**Brisbane Central Business District Bicycle User Group
CBD BUG**

Submission on Brisbane City Council draft City Reach Waterfront Master Plan

Figure 3- Austroads Part 6a – Figure 2.1 page 7

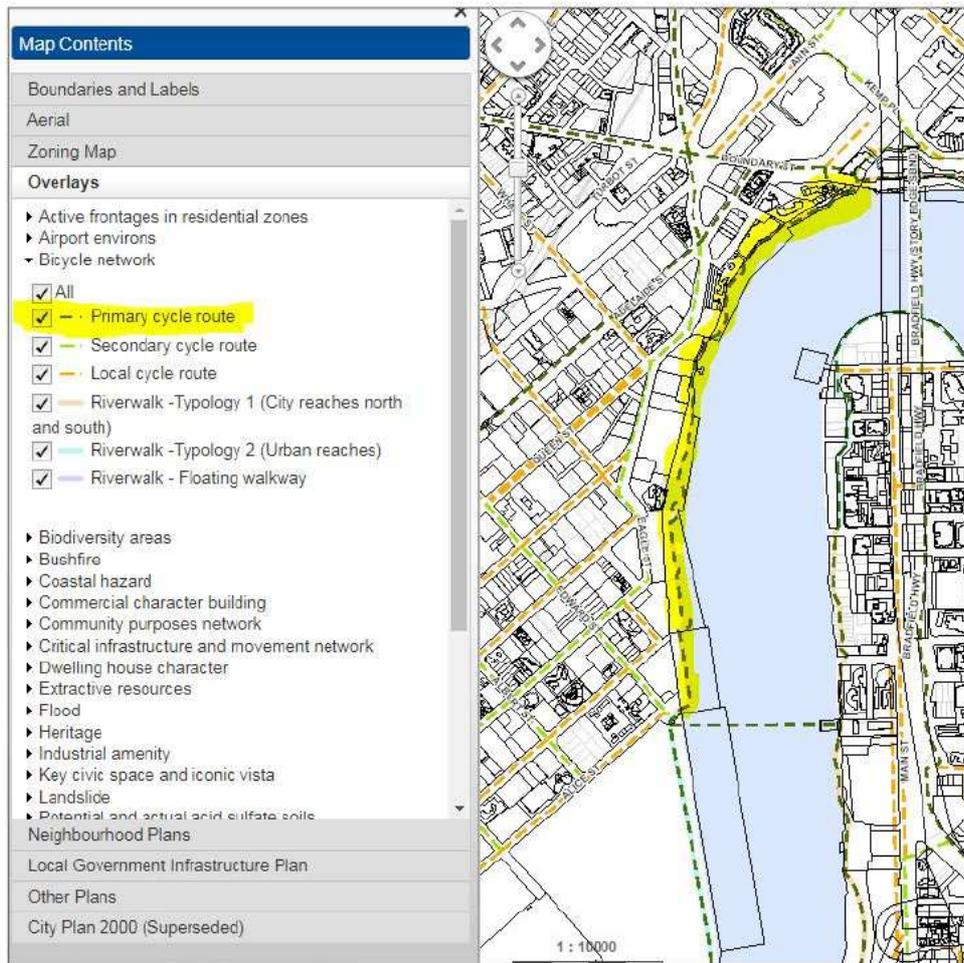
Nevertheless, we are extremely disappointed the current draft plan proposes the widened promenade would continue to be shared by people walking and cycling, instead of segregating this space to enhance safety and amenity for cyclists and pedestrians. Such a proposal contradicts previous advice that Brisbane City Council has provided to Howard Smith Wharves (Figure 1) and Queens Wharf (Figure 2). The proposal for shared use instead of segregation also contradicts AustRoads Part 6a (figure 3). The flow diagram on page 7 (of AustRoads document) clearly shows a segregated path as preferred.

Accordingly, as the safest approach we call for the master plan to include the segregation of pedestrians and cyclists. This will reduce legal liability for Council and align it with Austroads and TMR guidelines on high use active transport corridors.
